**TOWN OF NEWBURGH  
PLANNING BOARD  
TECHNICAL REVIEW COMMENTS**

**PROJECT NAME:** SUBDIVISION LANDS OF RIVERA-38 ROSALINE LANE  
**PROJECT NO.:** 22-24  
**PROJECT LOCATION:** SECTION 111, BLOCK 2, LOT 20 & 21  
**REVIEW DATE:** 11 NOVEMBER 2022  
**MEETING DATE:** 17 NOVEMBER 2022  
**PROJECT REPRESENTATIVE:** DARREN DOCE P.E.

RE: Two Lot Subdivision and Lot Line Revision  
38 Rosaline Lane – Lands of Rivera  
Section 111 Block 2 Lots 20 and 21  
Application No. 2022-24

**SUBDIVISION AND LOT LINE REVISION PLAN**

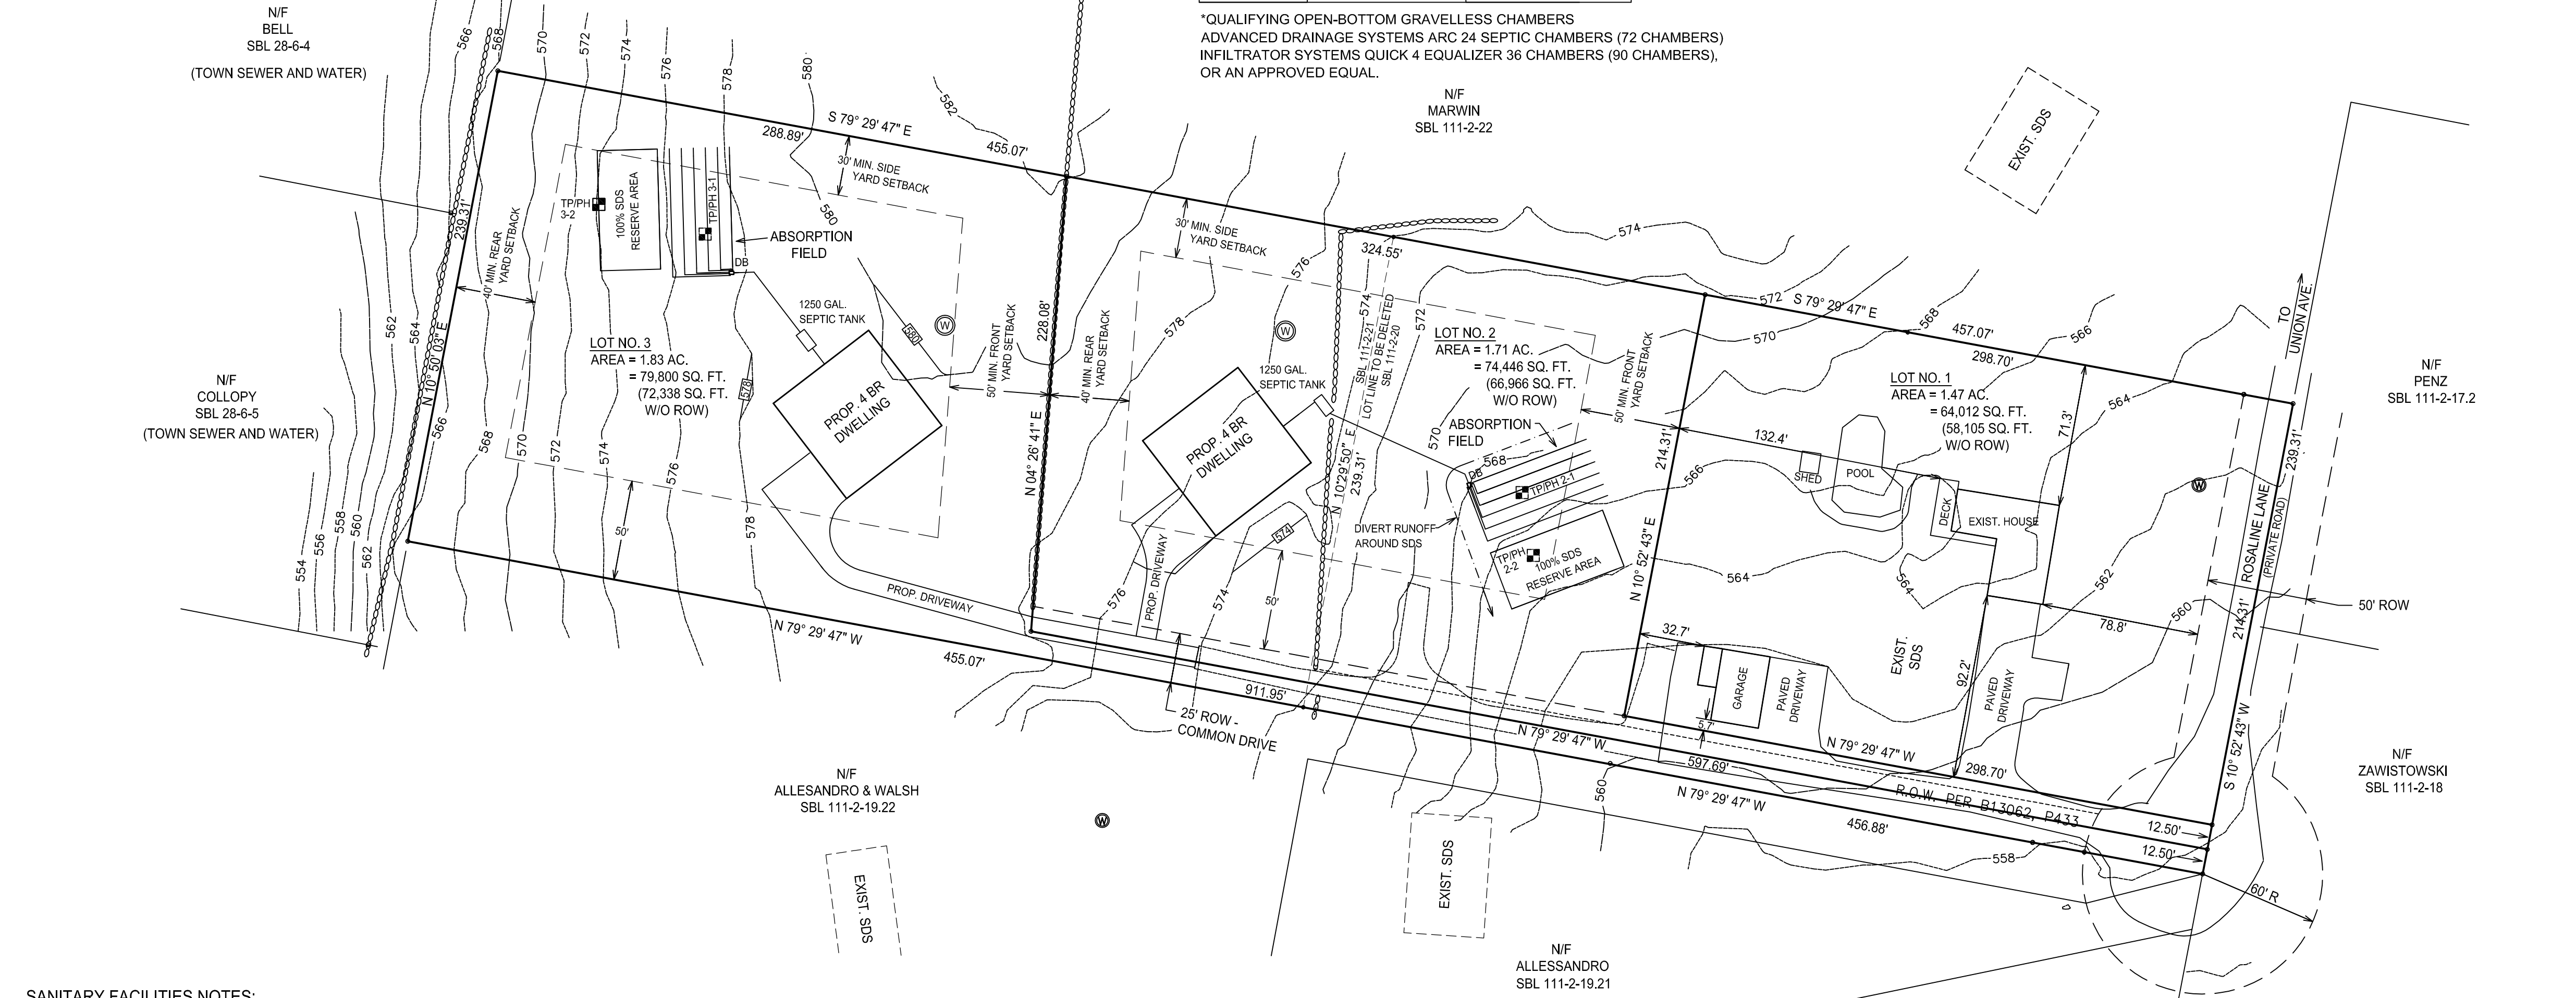
1. Project will require Town Board approval for three lots on a common driveway.
2. A note should be added to the plans requiring stake out of the houses prior to issuance of a building permit, as house locations are located in very close proximity to the proposed building envelopes.
3. Copy of the existing private road access in maintenance agreement for Rosaline Lane should be submitted for review to determine if additional lots are permitted and how additional lots will participate in the operation and maintenance the private roadway.
4. Adjoiner Notices must be sent.
